# SERVICE BULLETIN

ENGINE FUEL AND CONTROL — VARIABLE STATOR VANE (VSV) ACTUATOR  
— REVERSAL OF SERVICE BULLETIN V2500-ENG-73-0219 (LOW PRESSURE  
(LP) RETURN LINE RE-ROUTE PIPEWORK)

**V2500-ENG-73-0235**

The purpose of this Service Bulletin is to provide instructions for demodification, covering pressure release valve, engine pipe work, clipping points and blanking plug.

## REMOVAL FIGURE 1, SHEET 7

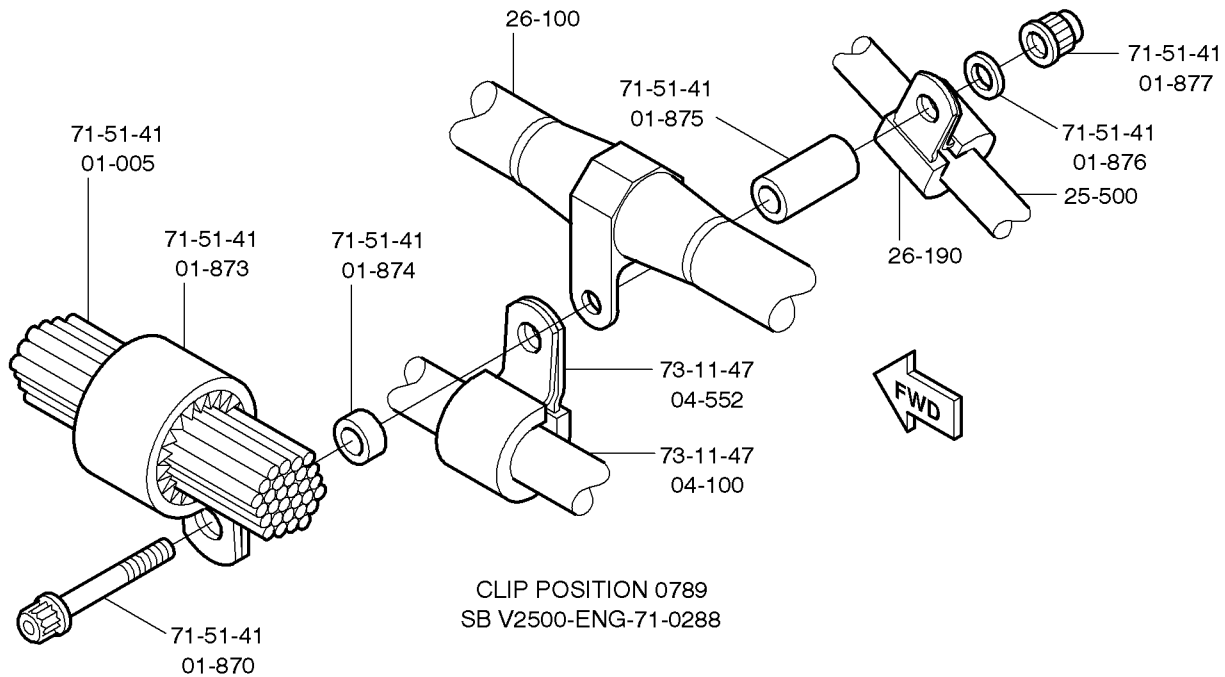
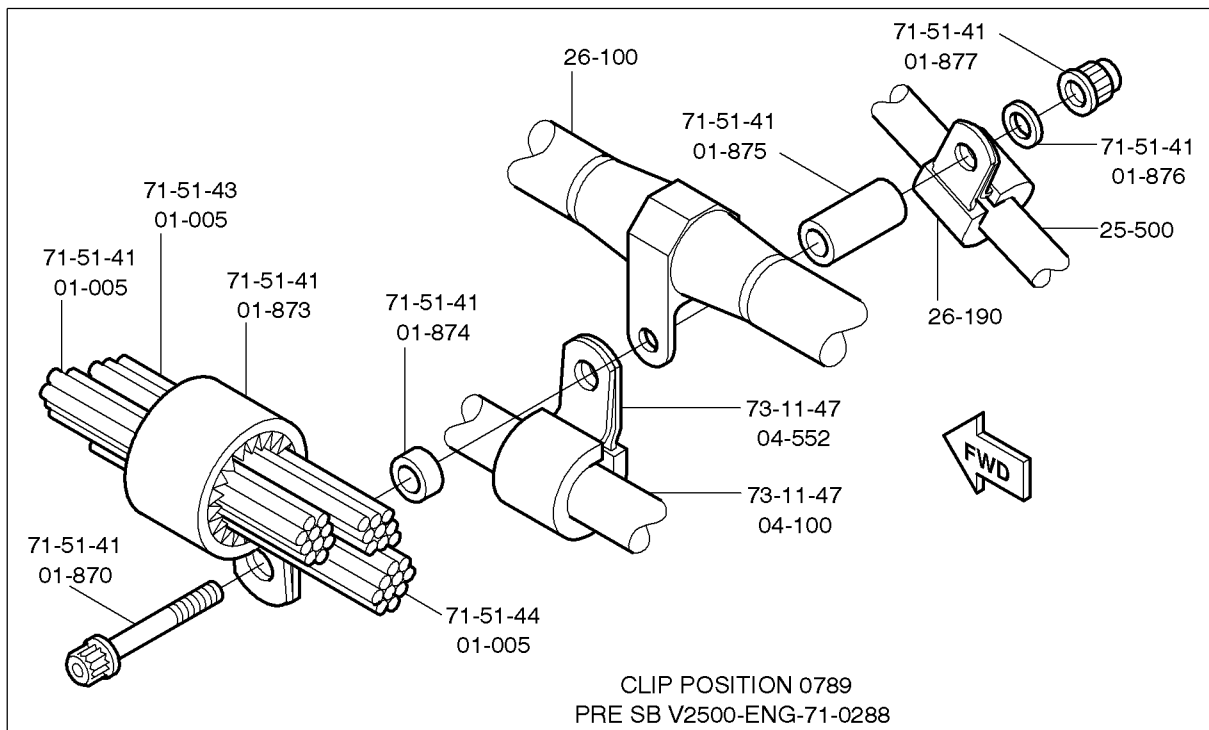
- D. At the changed clip position CP0789, refer to Fig. 1 (sheet 1 of 7 & sheet 7 of 7)
    - (1) Remove the bolt (71-51-41, 01-870), the spacers (71-51-41, 01-874) and (71-51-41, 01-875), the washer (71-51-41, 01-876) and the nut (71-51-41, 01-877) that attach the clip (71-51-41, 01-873), the new clip (73-11-47, 04-552), PN AS62406 and the new clip (73-11-49, 26-190), PN AS62404 to the bracket on tube (73-11-49, 26-100).

INSTALLATION  
FIGURE 2, SHEET 1

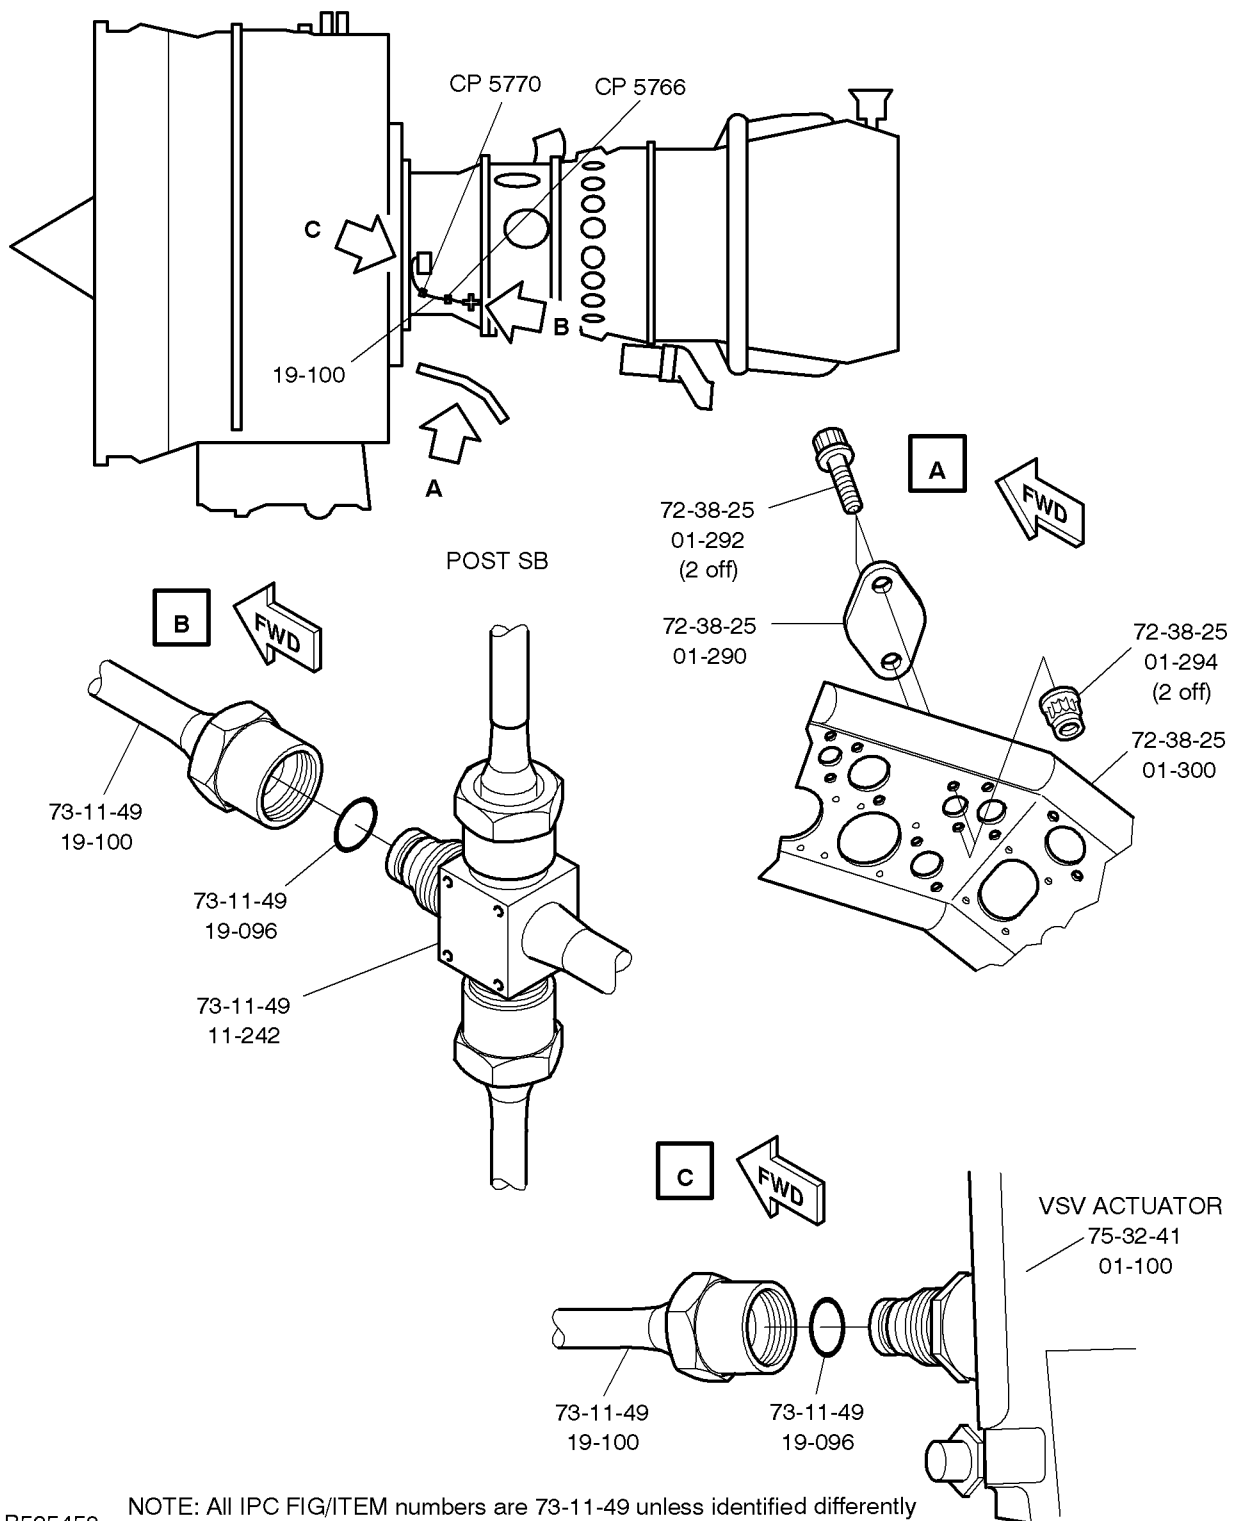
- H. Loosen the nuts on tubes (73-11-49, 33-100) and (73-11-49, 19-700) and remove them from the engine.
5. Install the fuel tube (73-11-49, 19-100) to the engine (Refer to the Aircraft Maintenance Manual, Chapter 75-32-41), refer to Fig. 2 (sheet 1 of 5 view B and C)

- C. Attach the tube nuts that attach the tube to the VSV actuator (75-32-41, 01-100) and the four way connector (73-11-49, 11-242), refer to Fig. 2 (sheet 1 of 5 view B and C).

9. Install the cover on the bifurcation panel, refer to Fig. 2 (sheet 1 of 5 view A)
  - A. Clean the mating surfaces of the bifurcation panel (72-38-25, 01-300) and the cover (72-38-25, 01-290).

- B. Add sealant between the bifurcation panel (72-38-25, 01-300) and the cover (72-38-25, 01-290), PN LK62478 circumferentially using CoMat. V08-013 Silcoset 152.

- C. Install the cover (72-38-25, 01-290), PN LK62478 to the bifurcation panel (72-38-25,01-300).
  - D. Install the two nuts (72-38-25, 01-294), PN 4W0002 and the two bolts (72-38-25, 01-292), PN 4W0163 that attach the cover (72-38-25, 01-290) to the bifurcation panel (72-38-25, 01-300).

- E. Torque the two nuts (72-38-25, 01-294) to 85 to 105 lbf in. (10 to 12 Nm).
10. Get access to the fuel tube assembly (73-11-47, 01-100) PN 745-5650-505 that is installed on the left side of the fan case, refer to Fig. 1 (sheet 1 of 7 & sheet 2 of 7 view H)

## INSTALLATION FIGURE 2, SHEET 2

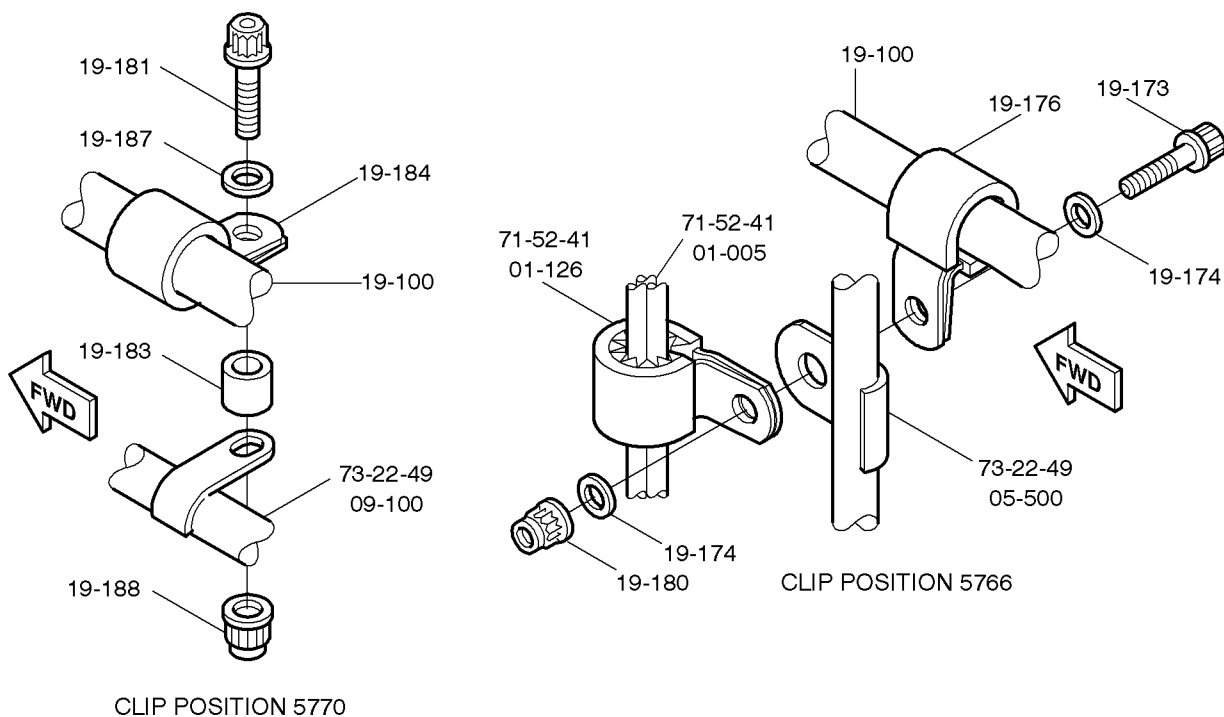
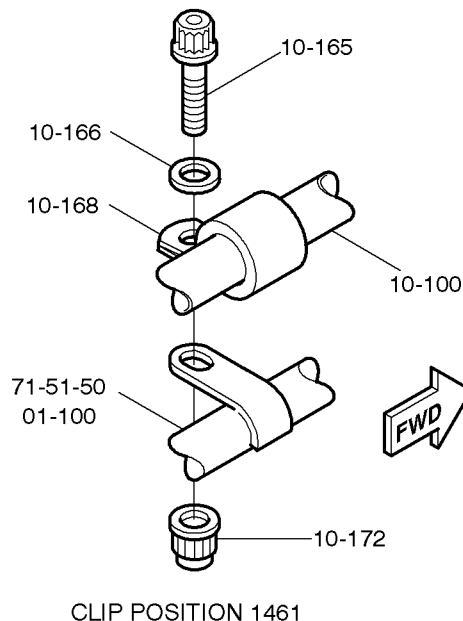
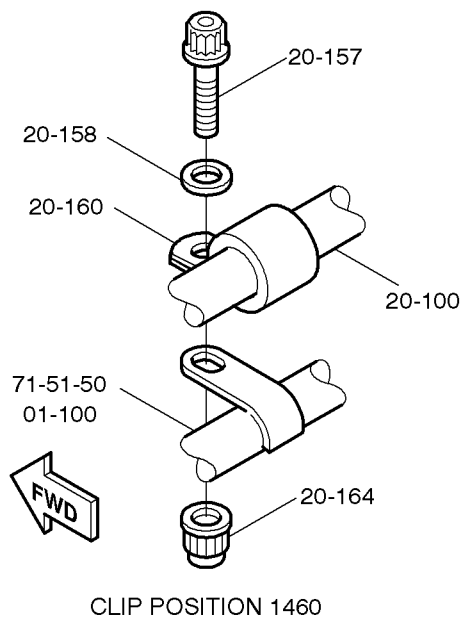
- D. At the clip position CP5770, refer to Fig. 2 (sheet 2 of 5)
    - (1) Install the nut (73-11-49, 19-188), the washer (73-11-49, 19-187), the spacer (73-11-49, 19-183) and the bolt (73-11-49, 19-181), PN 4W0106, that attach the clip (73-11-49, 19-184), PN 400WSS6 to the lug on tube (73-22-49, 09-100).

- E. At the clip position CP5766, refer to Fig. 2 (sheet 2 of 5)
    - (1) Install the nut (73-11-49, 19-180), the two washers (73-11-49, 19-174) and the bolt (73-11-49, 19-173), PN 4W0103 that attach the clip (73-11-49, 19-176),

- H. At the changed clip position CP1460, refer to Fig. 2 (sheet 2 of 5)
  - (1) Install the nut (73-11-49, 20-164), the bolt (73-11-49, 20-157), PN 4W0102 and the washer (73-11-49, 20-158) that attach the clip (73-11-49, 20-160) to the lug on tube (71-51-50, 01-100).

- I. At the changed clip position CP1461, refer to Fig. 2 (sheet 2 of 5)
  - (1) Install the nut (73-11-49, 10-172), the washer (73-11-49, 10-166) and the bolt (73-11-49, 10-165), PN 4W0102 that attach the clip (73-11-49, 10-168) to the lug on tube (71-51-50, 01-100).

- (1) At the clip position CP5770 torque the nut (73-11-49, 19-188) to 36 to 45 lbf in. (4 to 5 Nm).
    - (2) At the clip position CP5766 torque the nut (73-11-49, 19-180) to 36 to 45 lbf in. (4 to 5 Nm).

- K. Torque the three nuts (73-11-49, 20-164), (73-11-49, 10-172) and (71-51-41, 02-906) of the clip positions CP1460, CP1461 and CP1465 to 36 to 45 lbf in. (4 to 5 Nm).

### INSTALLATION FIGURE 2, SHEET 3

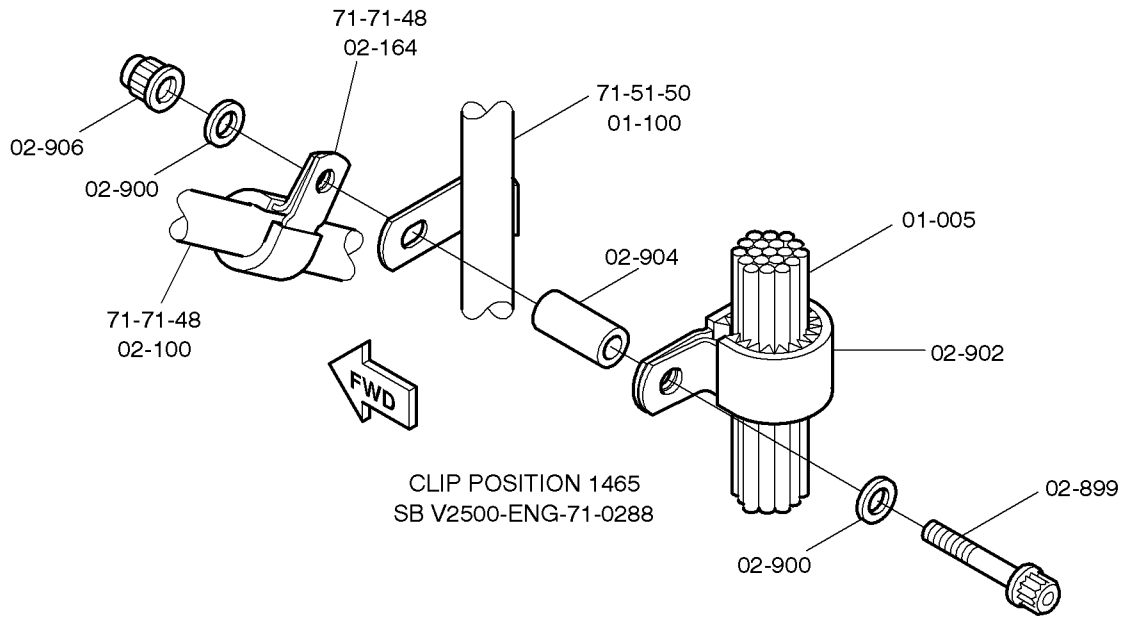
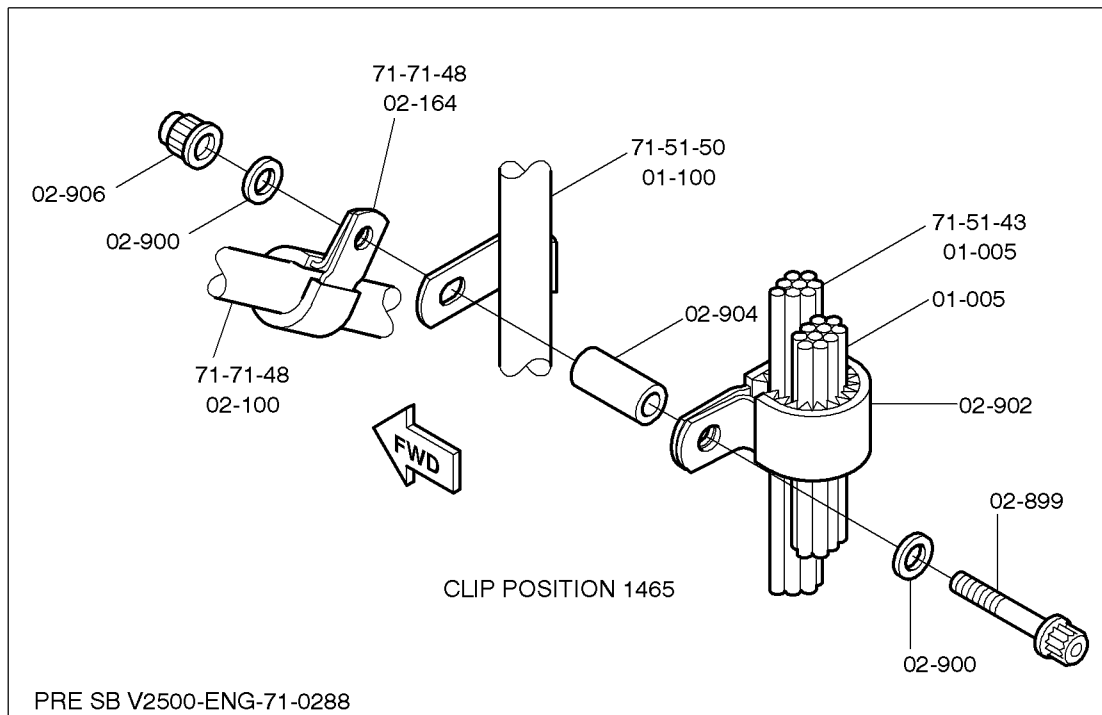
- J. At the changed clip position CP1465, refer to Fig. 2 (sheet 3 of 5)
  - (1) For pre SBE 71-0288 engines: Install the nut (71-51-41, 02-906), the two washers (71-51-41, 02-900), the spacer (71-51-41, 02-904) and the bolt (71-51-41, 02-899), PN 4W0114 that attach the clip (71-51-41, 02-902), PN AS62215 and the clip (71-71-48, 02-164) to the lug on tube (71-51-50, 01-100).

- (2) For SBE 71-0288 engines: Install the nut (71-51-41, 02-906), the washer (71-51-41, 02-900), the spacer (71-51-41, 02-904) and the bolt (71-51-41, 02-899), PN 4W0114 that attach the clip (71-51-41, 02-902) and the clip (71-71-48, 02-164) to the lug on tube (71-51-50, 01-100).

# INSTALLATION FIGURE 2, SHEET 4

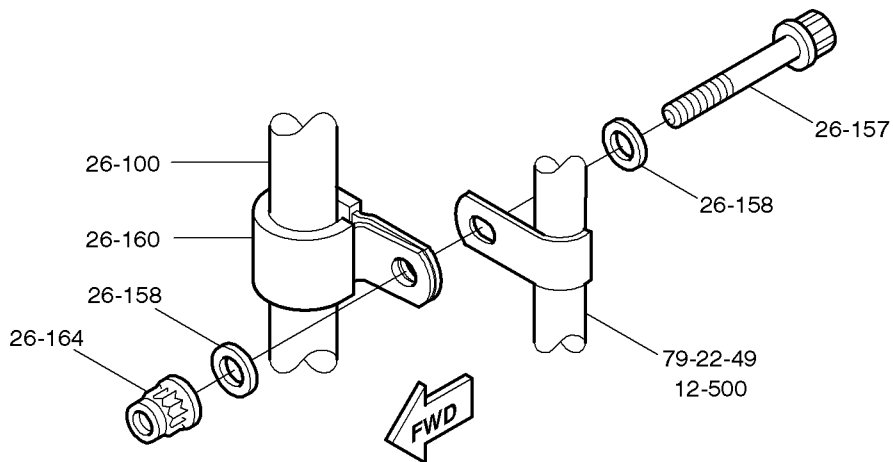
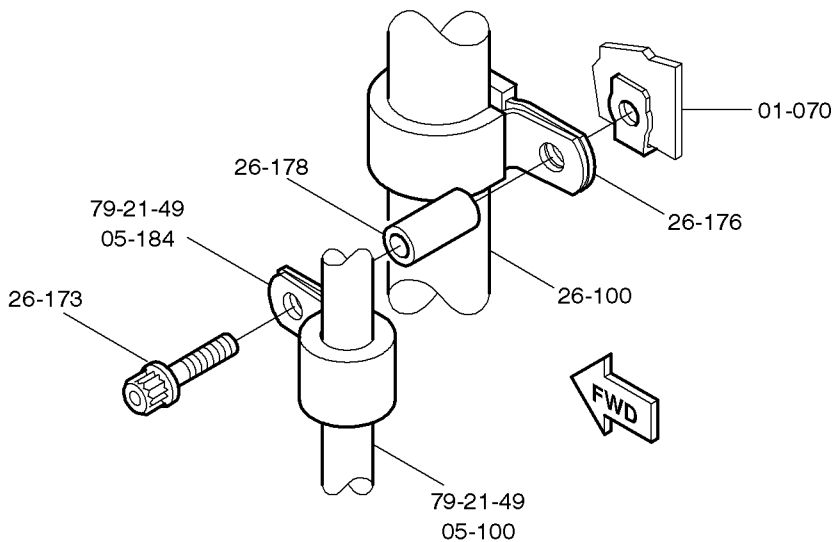
- G. At the changed clip position CP0921, refer to Fig. 2 (sheet 4 of 5)
  - (1) Install the nut (73-11-49, 26-164), the bolt (73-11-49, 26-157), PN AS20908 and the washer (73-11-49, 26-158) that attach the clip (73-11-49, 26-160) to the lug on tube (79-22-49, 12-500).

- I. At the changed clip position CP1072, refer to Fig. 2 (sheet 4 of 5)
  - (1) Install the bolt (73-11-49, 26-173), PN 4W0116 and the spacer (73-11-49, 26-178) that attach the clip (79-21-49, 05-184) and the clip (73-11-49, 26-176), PN 400WSS16 to the bracket (24-21-49, 01-070).

- J. Torque the two nuts (73-11-49, 26-164) and (71-51-41, 01-877) of the clip Positions CP0921 and CP0789 to 36 to 45 lbf in. (4 to 5 Nm).
- K. Torque the bolt (73-11-49, 26-173) of the clip position CP1072 to 36 to 45 lbf in. (4 to 5 Nm).

INSTALLATION  
FIGURE 2, SHEET 5

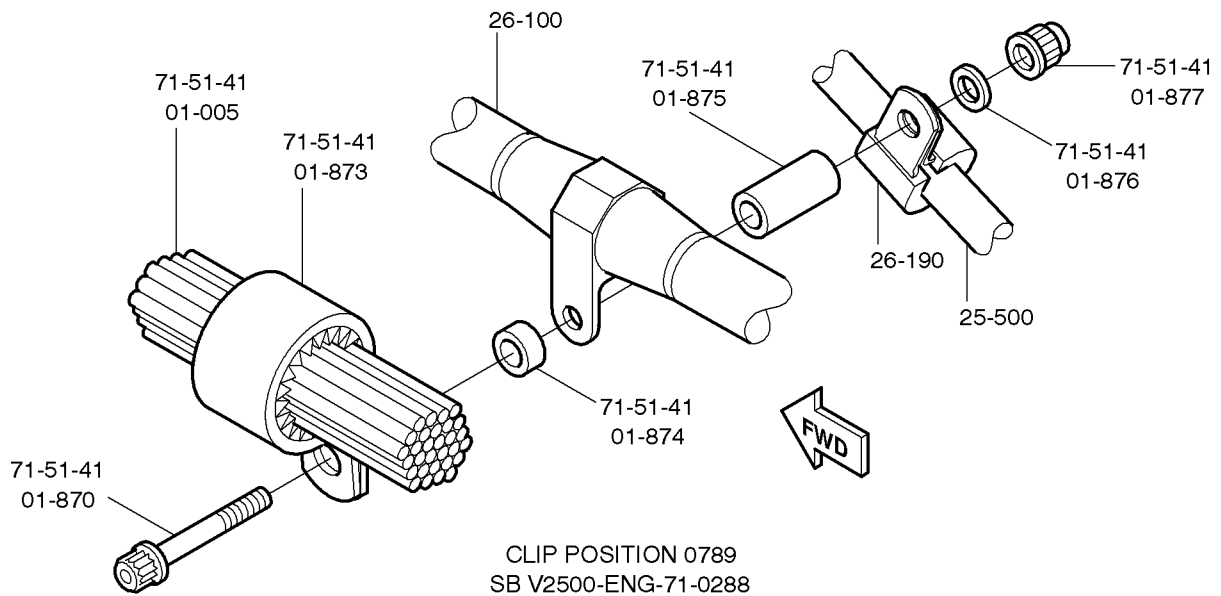
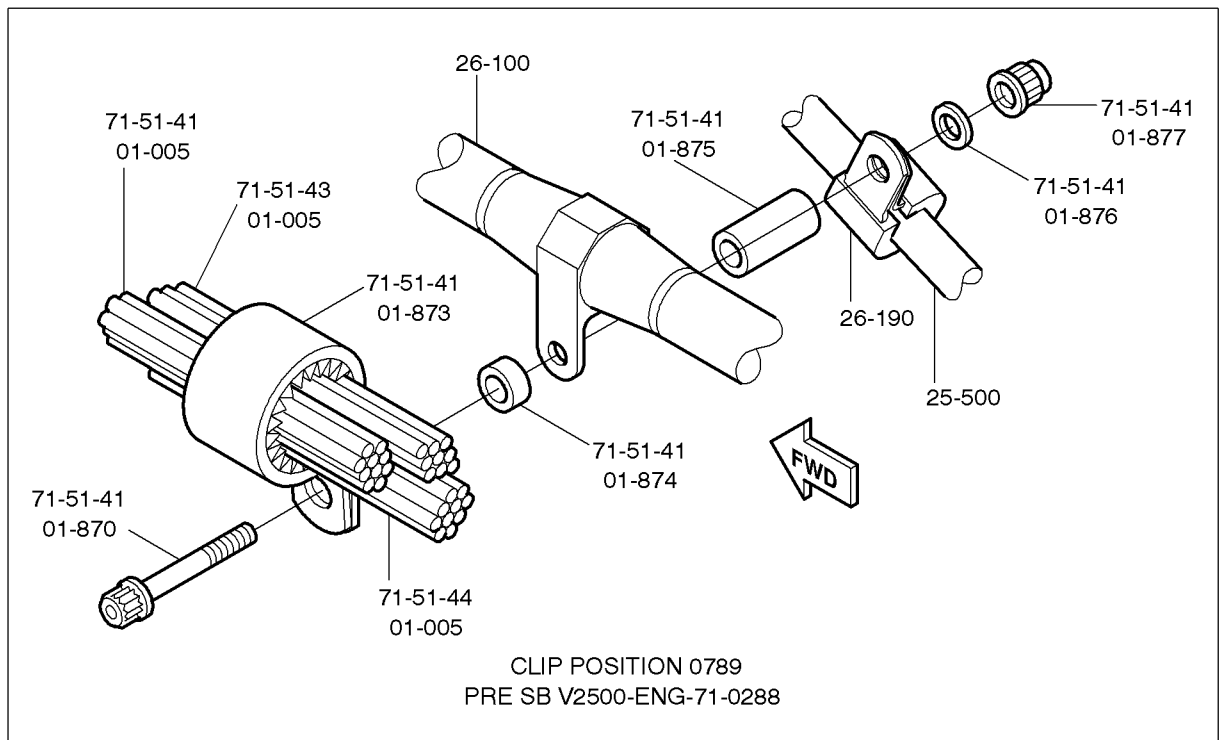
- H. At the changed clip position CP0789, refer to Fig. 2 (sheet 5 of 5)
  - (1) Install the nut (71-51-41, 01-877), the washer (71-51-41, 01-876), the spacers (71-51-41, 01-875) and (71-51-41, 01-874) and the bolt (71-51-41, 01-870) that attach the clip (71-51-41, 01-873) and the clip (73-11-49, 26-190), PN 400WSS4 to the bracket on tube (73-11-49, 26-100).
